Service Bulletin 001/09

Ride: Sky Loop
Component: Seat Locking Device

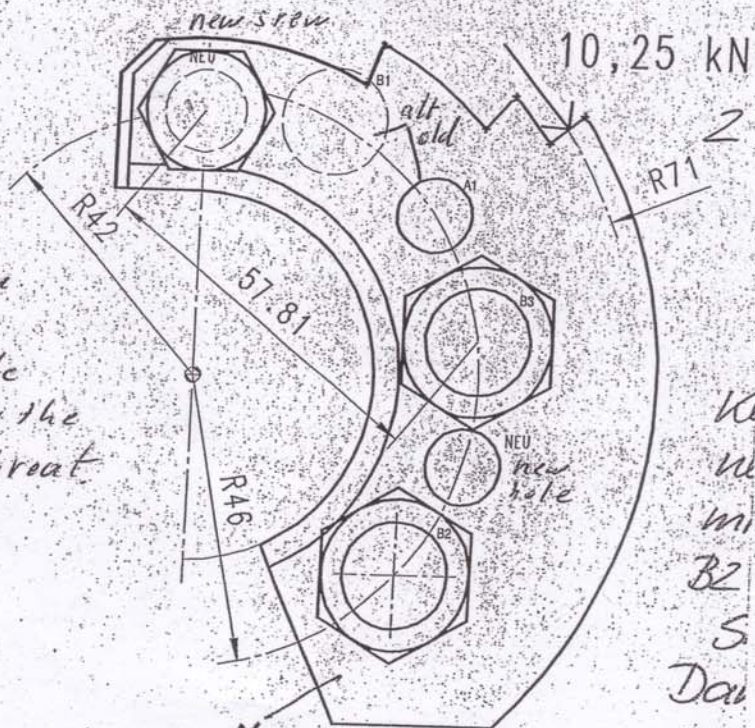
85164 alt
old

Die neue konstruktive Lösung ist in Bild 3 dargestellt.

New
808827
new

Neue Zahnplatte als
Bohrschablone verwenden

Use ~~the~~ segment as plate
to drill the new holes for the
pin and the additional throat.
